Stantec Consulting Services Inc.
65 Network Drive, 2nd Floor, Burlington, MA 01803

March 3, 2021
File: MassDOT Project No. 606635 / 109597

**Reference: Request for Amendment to Order of Conditions (MassDEP File No. 239-815)
Reconstruction of Needham Street and Winchester Street, Newton Massachusetts**

FIGURE 9

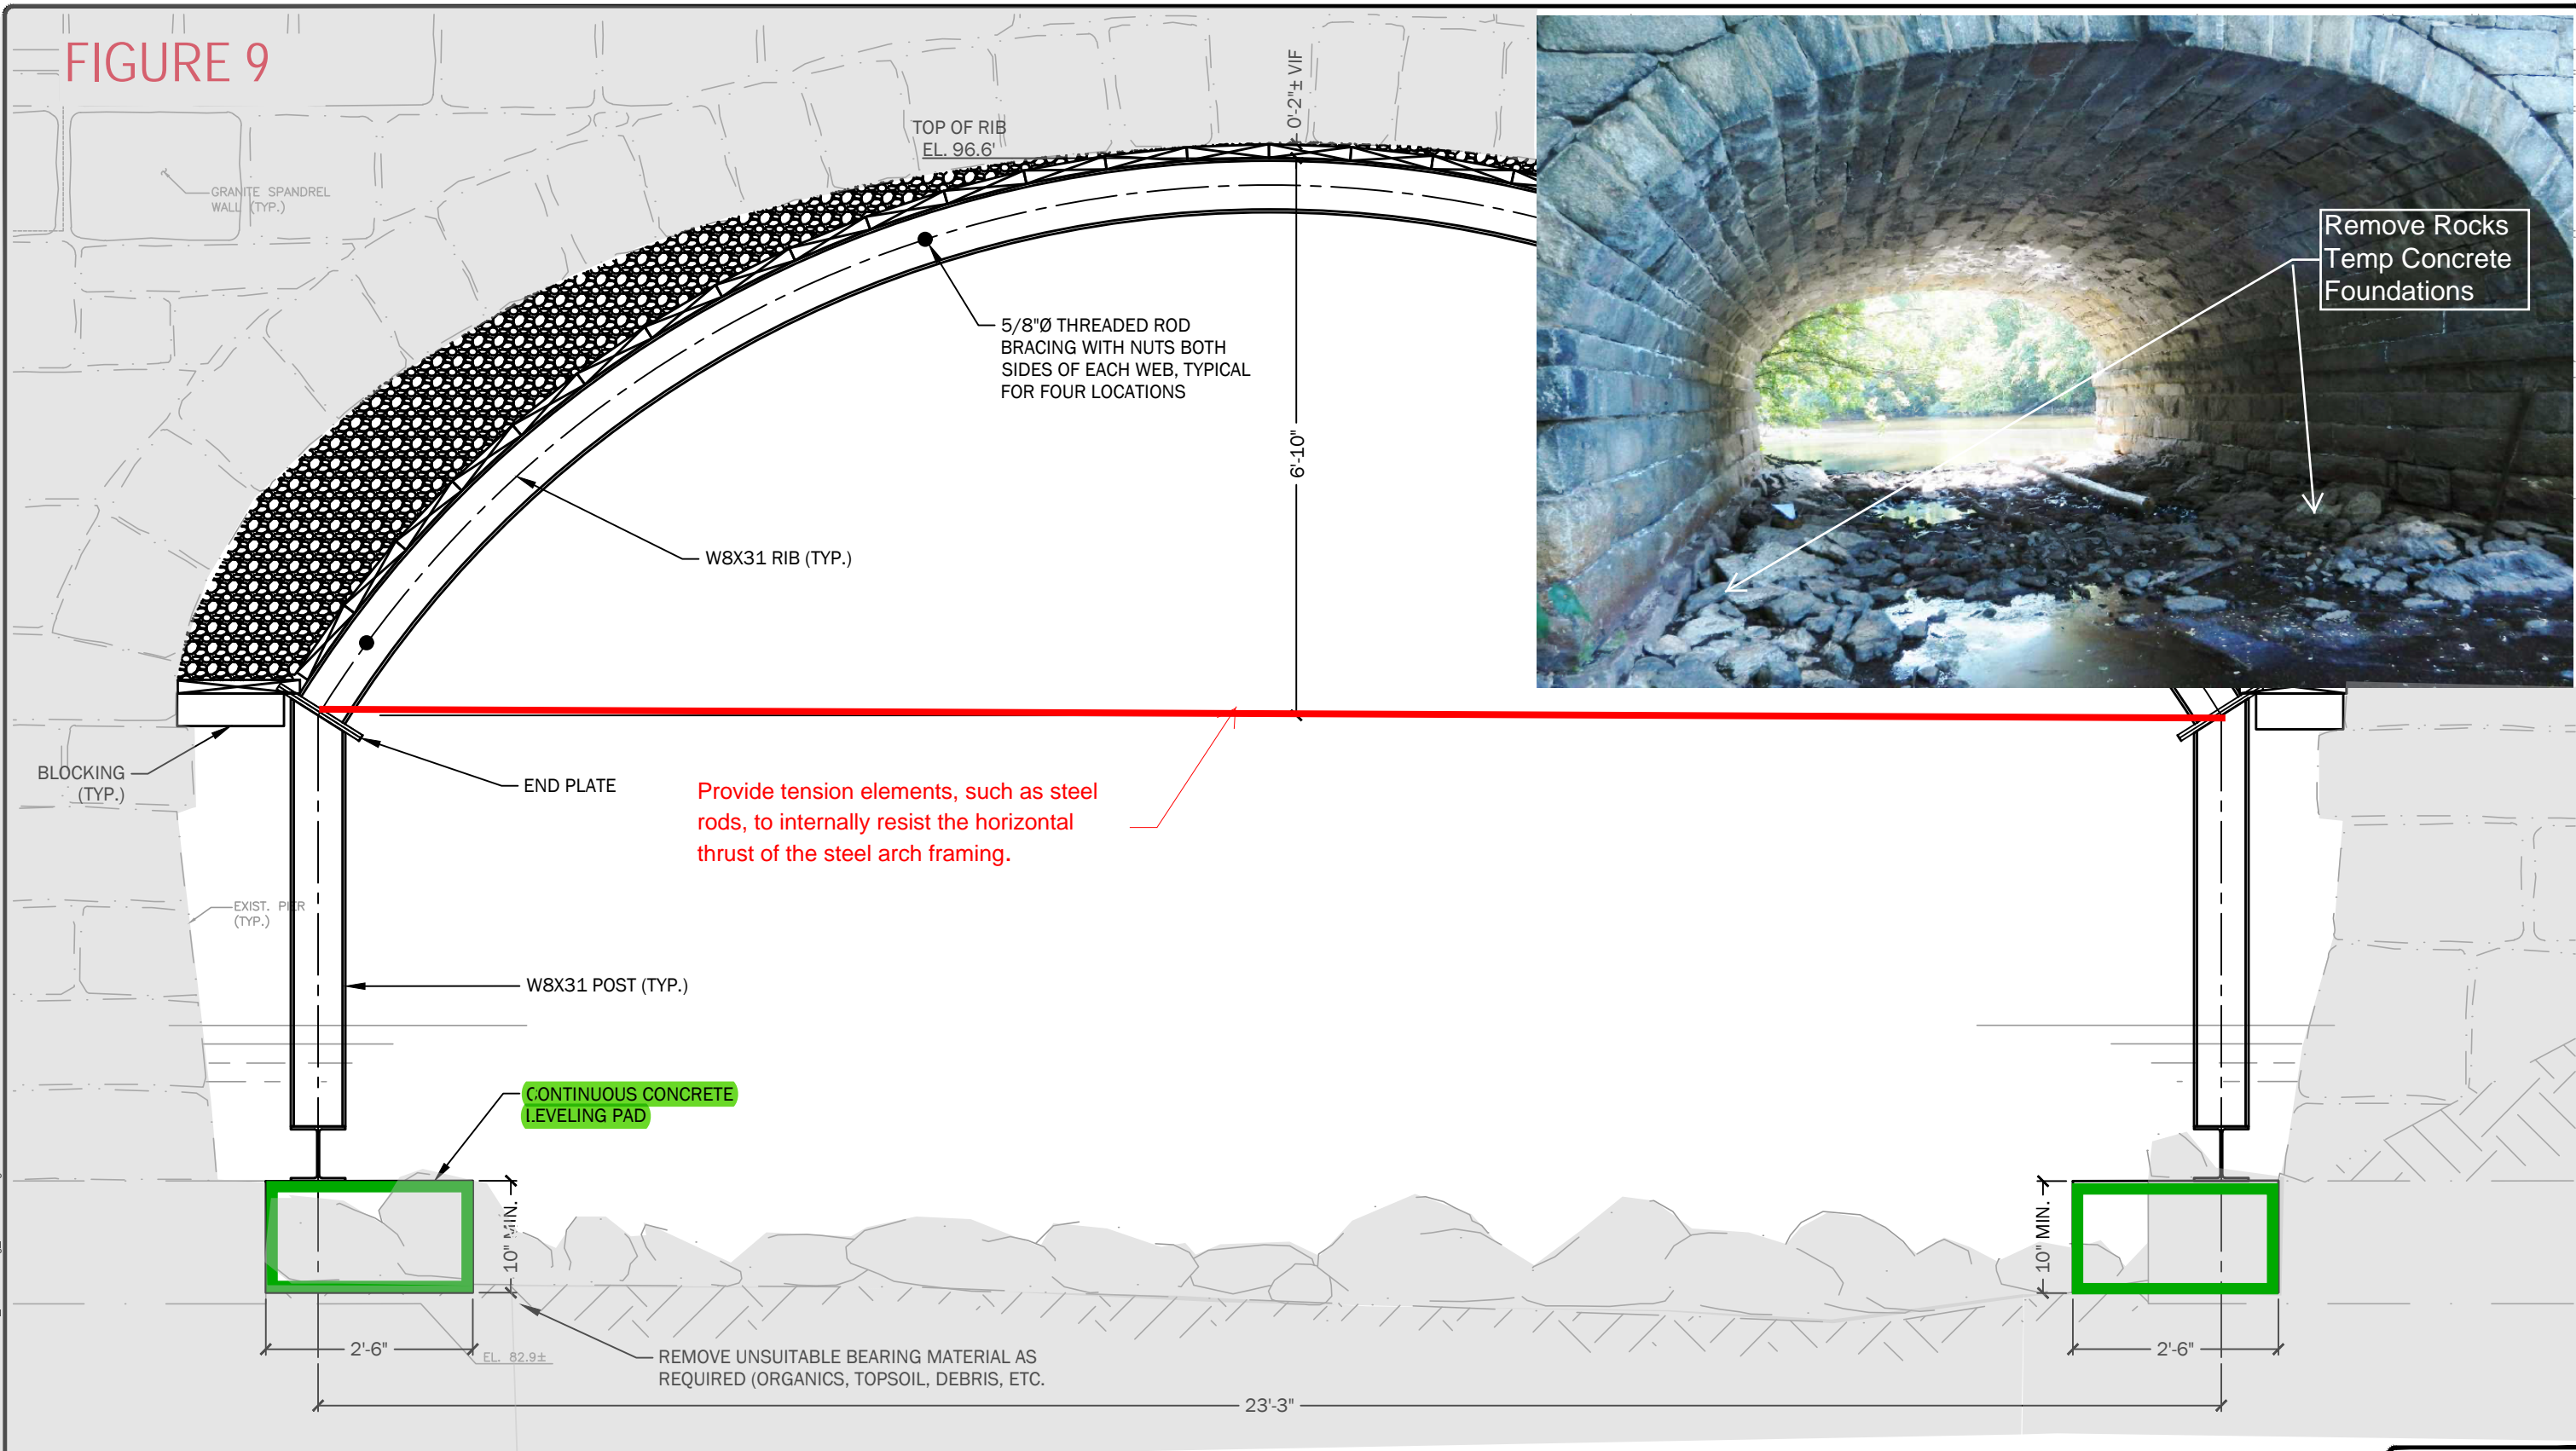
Construction staging within the river is necessary to support this effort. For the northern span, a 3,000 SF area will need to be established in LUWW to install a temporary support shield. Existing rocks and debris will be removed from under the arch and the area dewatered to place concrete footings to support the construction. Sandbags will be set up at the perimeter of the dewatering area and used for dewatering control. See Figures 6-9.

FIGURE 10 - FLOATING TURBIDITY BARRIER

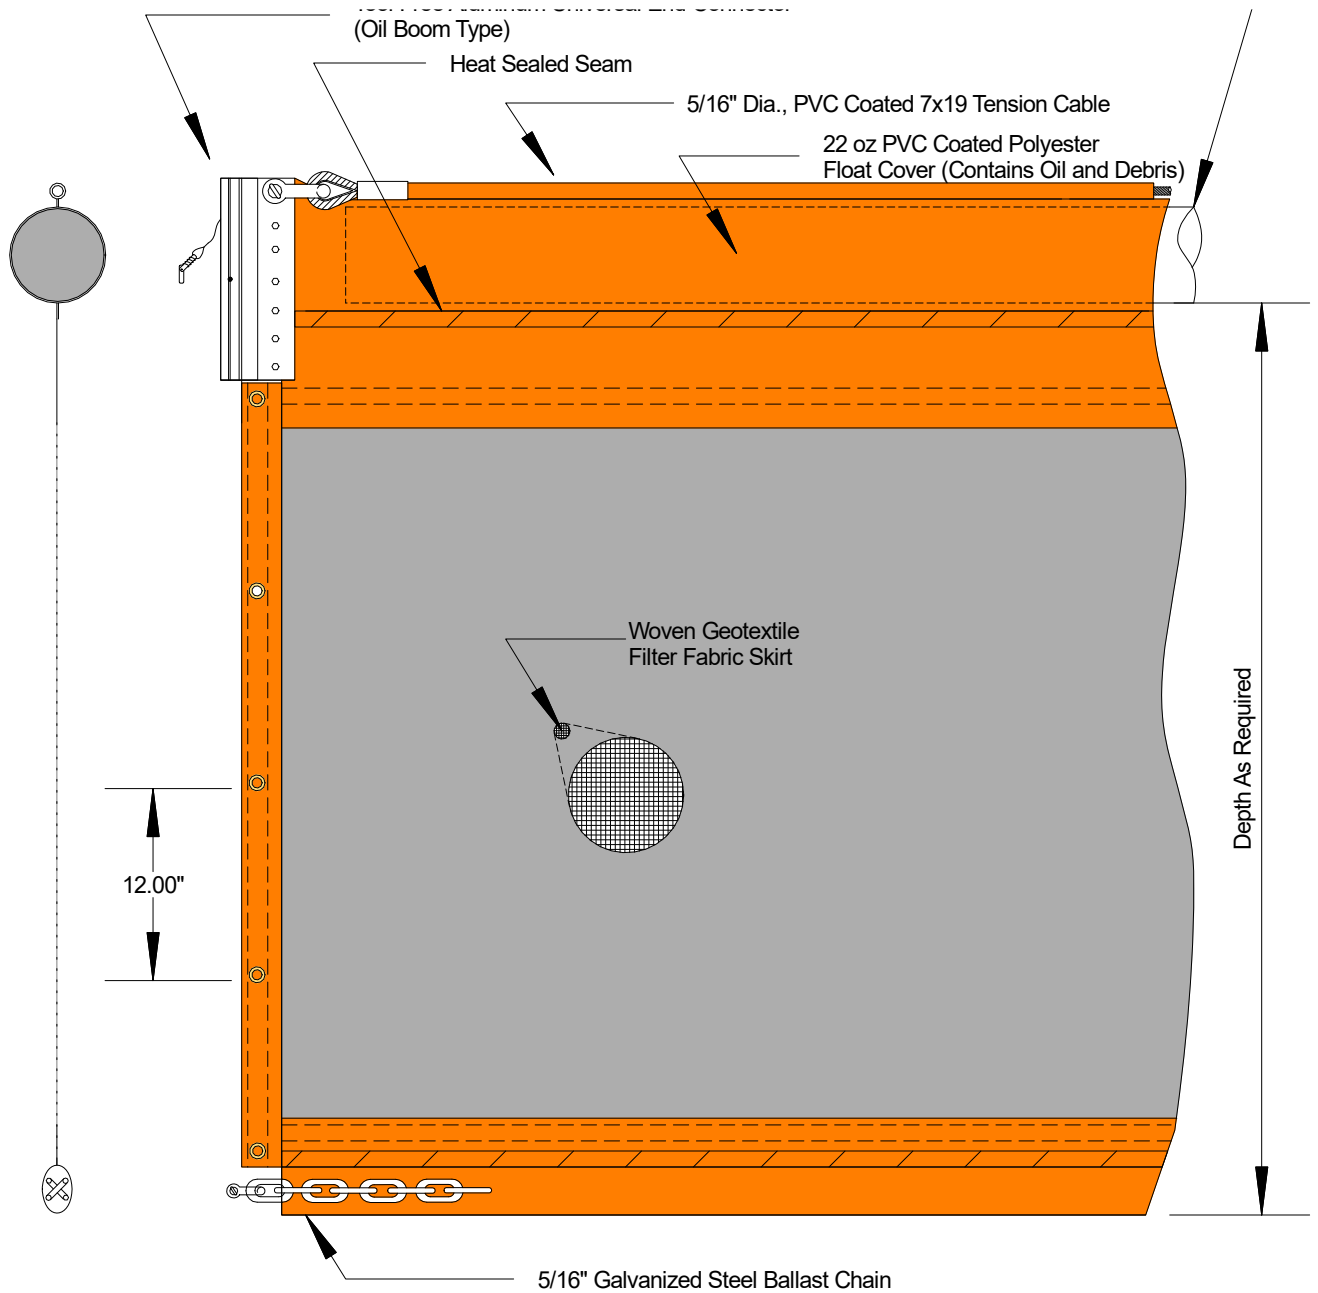
A turbidity curtain will be used on the downstream side of the northern arch. For the center span, a concept design being considered for the temporary support in the center span uses floating wooden rafts (8'x15') and a power boat for installation and demolition of the temporary supports. It is likely the navigable way will be closed to users during the installation and demolition. This work is to take place in BLSF and LUWW. See Figures 8 and 10.

FIGURE 12 – IMPACT AREA 100-FT BUFFER ZONE

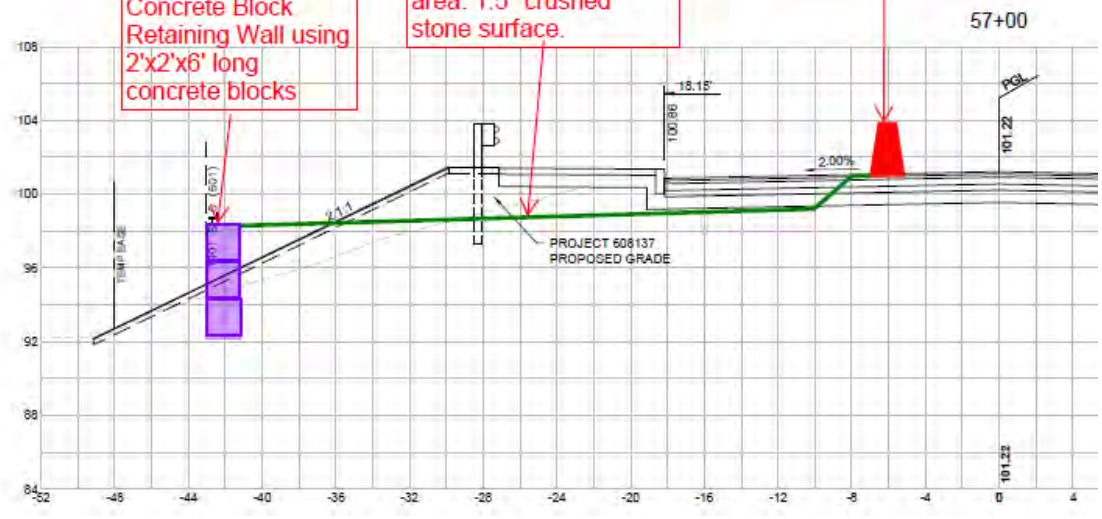
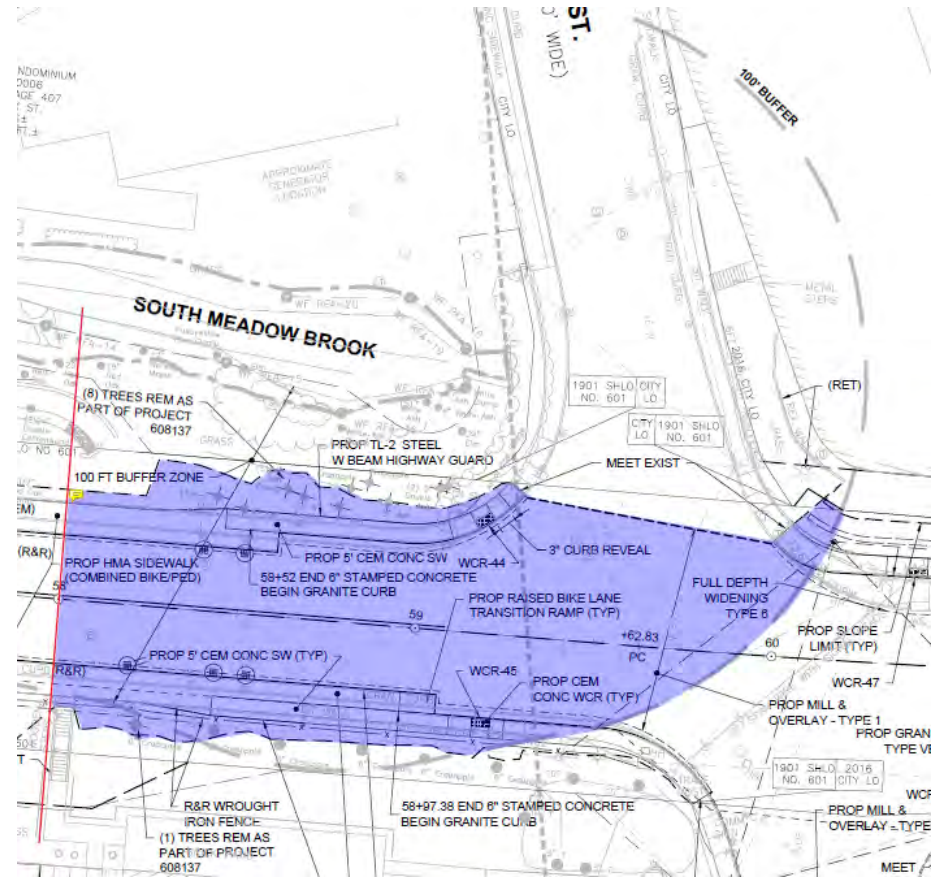
Authorization for work within jurisdictional resource include LUWW, BLSF, and Riverfront Area associated with the Charles River and South Meadow Brook, and the 100-foot Buffer Zone to Banks of the Charles River and South Meadow Brook. See Table 1 for a summary of what temporary and permanent resource alterations were authorized under the OOC and the proposed changes requested under this AOC. See Figures 8 and 12-14 for an overview of temporary impact locations in each jurisdictional resource area.

Approximately 25,100 SF of temporary impacts are anticipated for the work in the area from the Charles River to Oak Street. The noted impacts to Buffer Zone overlap with the impacts to Riverfront Area and approximately 9,800 SF are within the footprint of the already disturbed impervious roadway layout. Temporary impacts within the 100-foot buffer zone are not expected to result in adverse effects.

Area of work within 100-foot buffer zone = 25,100 sf

FIGURE 13 – IMPACT AREA BORDERING LAND SUBJECT TO FLOODING

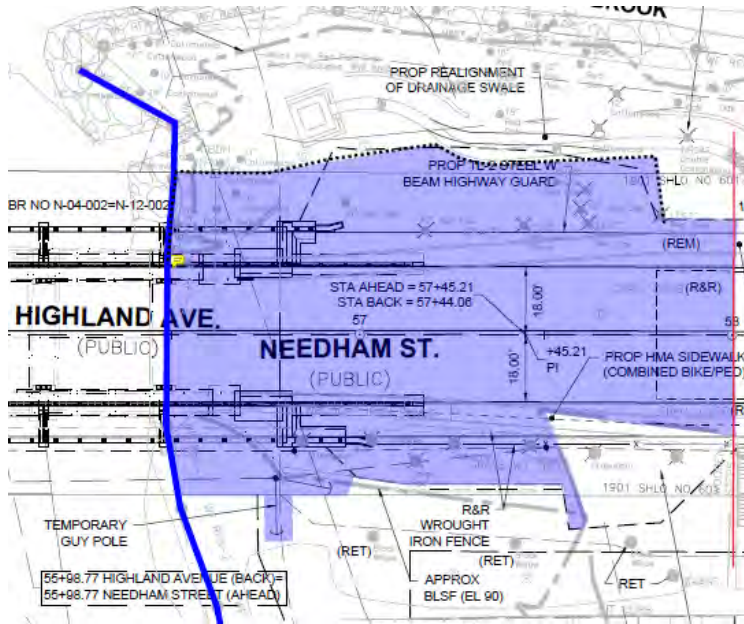
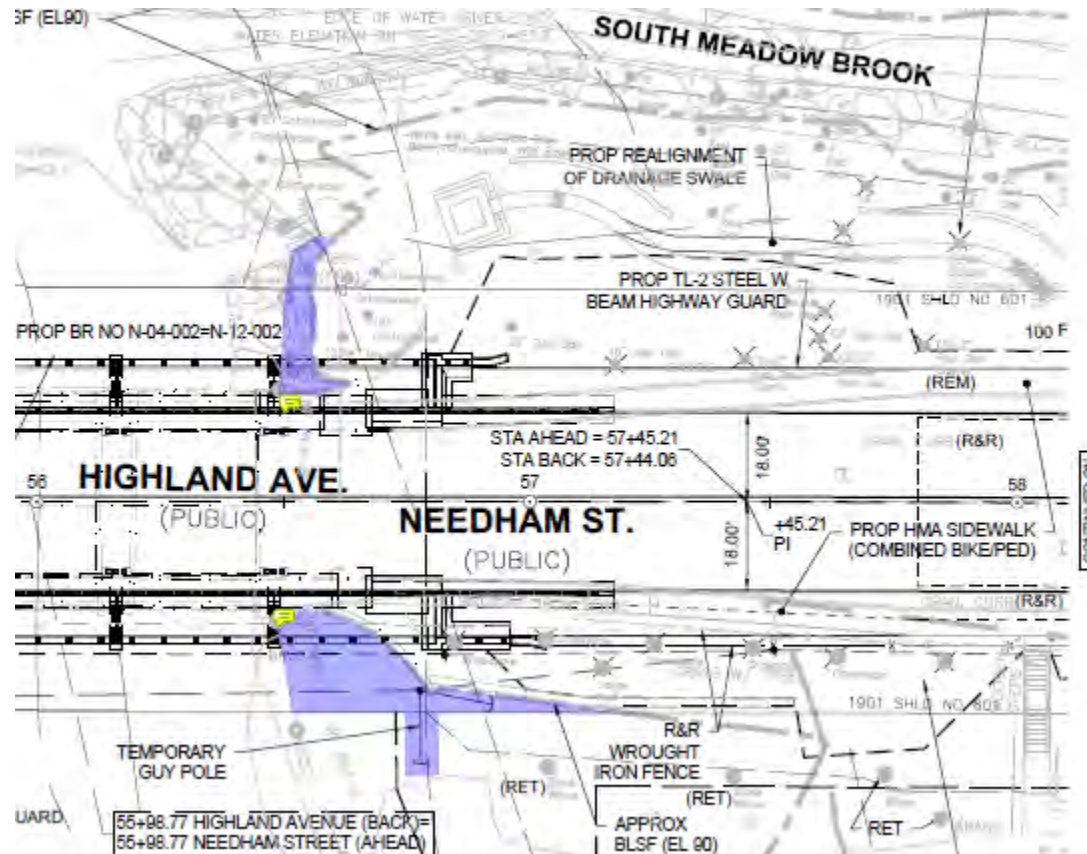
As outlined in the original NOI application, project implementation will result in the net increase of 165.6 CY of flood storage. The additional work proposed in BLSF will not change the volume of flood capacity and, therefore, the proposed changes will result in no adverse effects to BLSF.

Area of work within BLSF = 850 sf (No change in flood storage elev)

FIGURE 14 – IMPACT AREA RIVERFRONT AREA

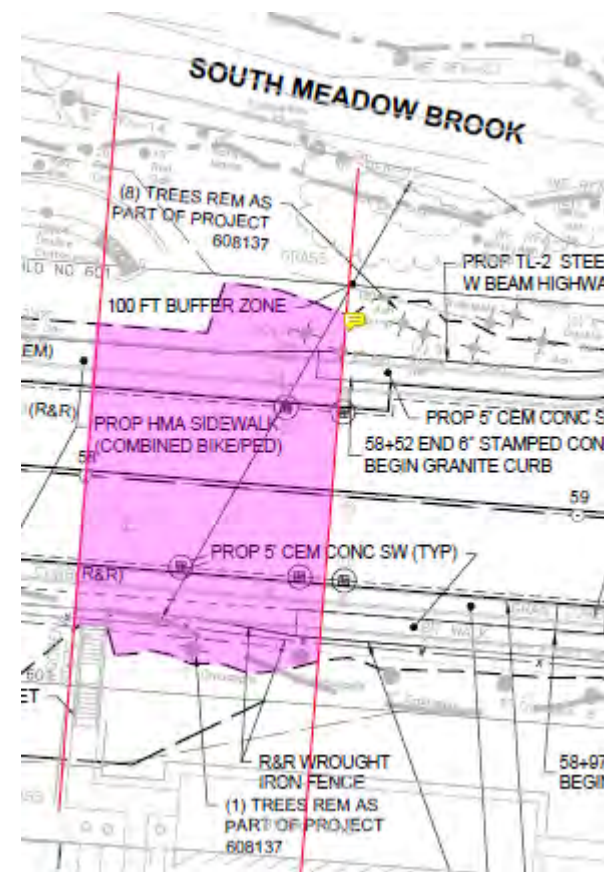
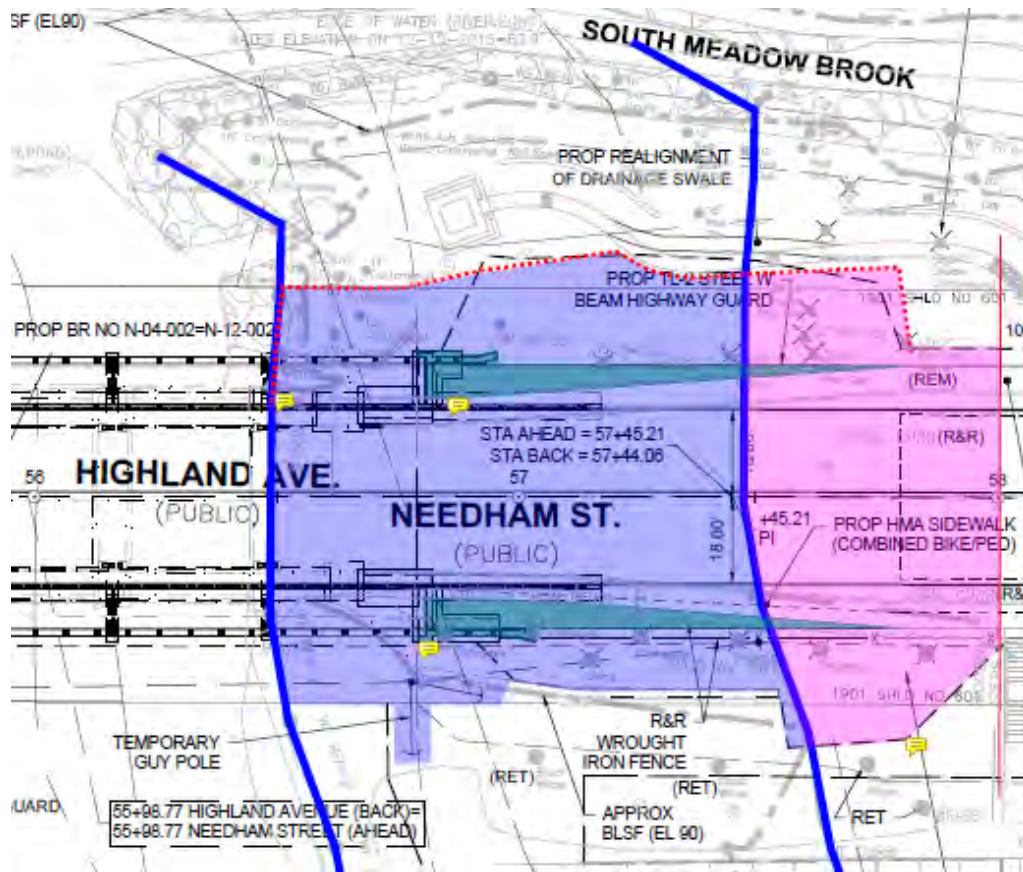
Temporary impacts will result in no adverse effects as the work includes resurfacing an existing roadway and side slope regrading. Permanent impacts include the area of retaining walls required to hold up the cantilevered sidewalks and a strip of roadway widening.

Total impacts = 16,600 sf
 Temporary impacts = 15,815 sf
 Permanent impacts = 785 sf
